No. 95-3

MCM 3.0L, LX Starter Motor Bolt Breakage

74517

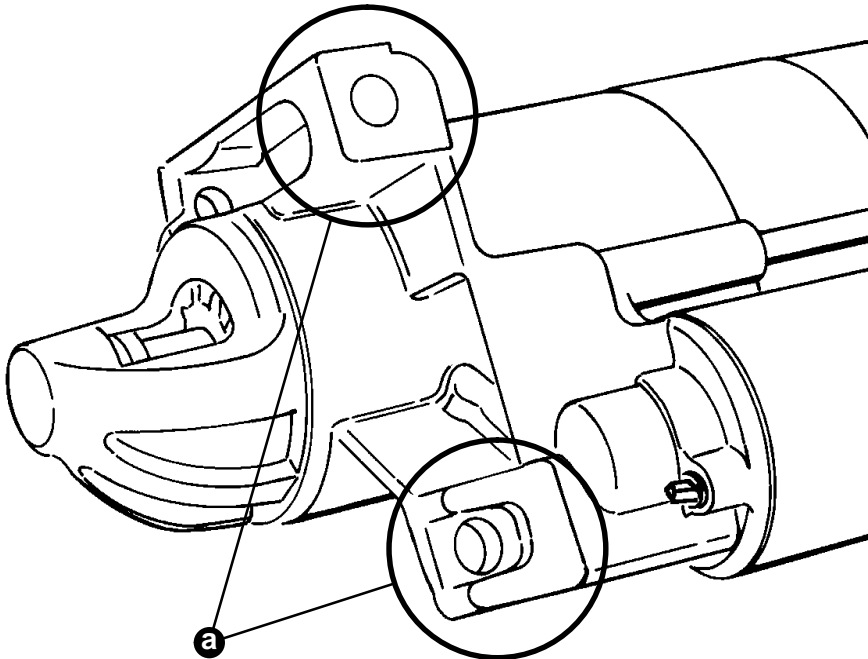
Before ordering parts, remove starter motor and look for cracks in the starter motor drive housing at location showed below.

a. Inspect For Cracks. If Cracks Are Found, Replace Complete Starter Motor.

Starter Bracket Installed

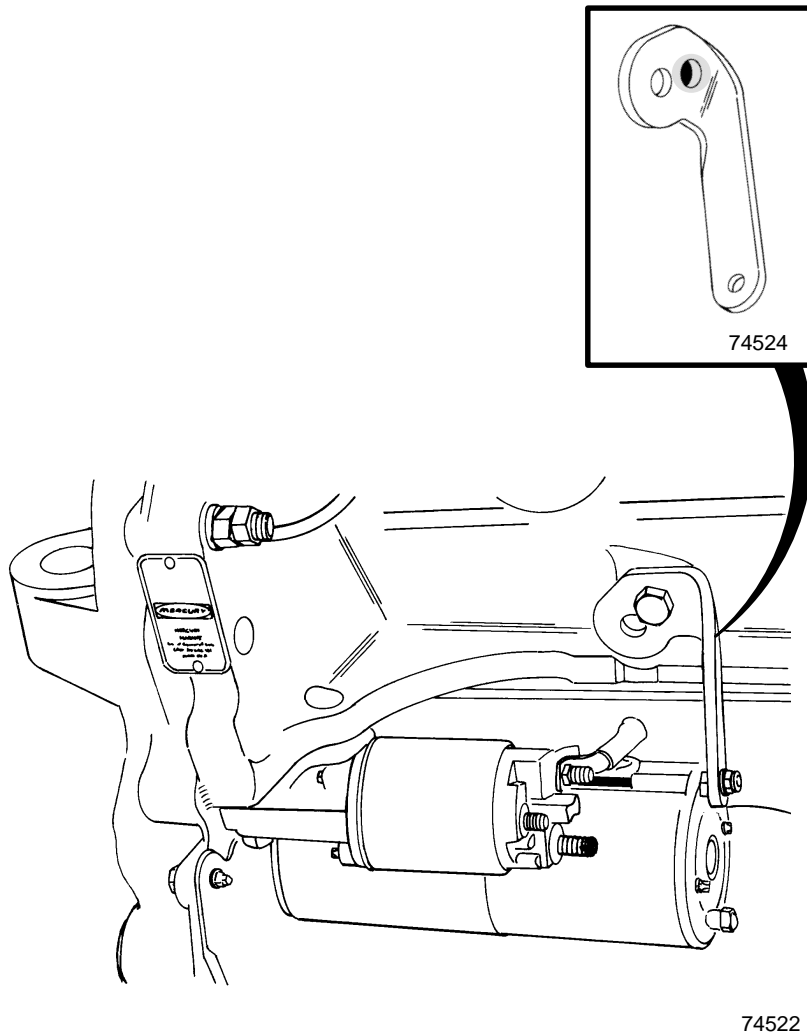
At certain engine RPM's, the end of the Delco PG200 or PG260 starter motors can be subjected to a harmonic vibration. If the customer runs their engine for long periods at this RPM, the starter motor attaching bolts can break. Sometimes, the mounting pads on the starter motor drive housing either are broken off or cracked.

Order either the Starter Motor Bracket Kit or a complete Starter Motor as required. Follow the instructions that come in the kits.

(1) 807213A 1 Starter Motor Bracket Kit.

(1) 50-806963A 4 Starter Motor Complete, (Bracket Kit is packaged with the Starter Motor).
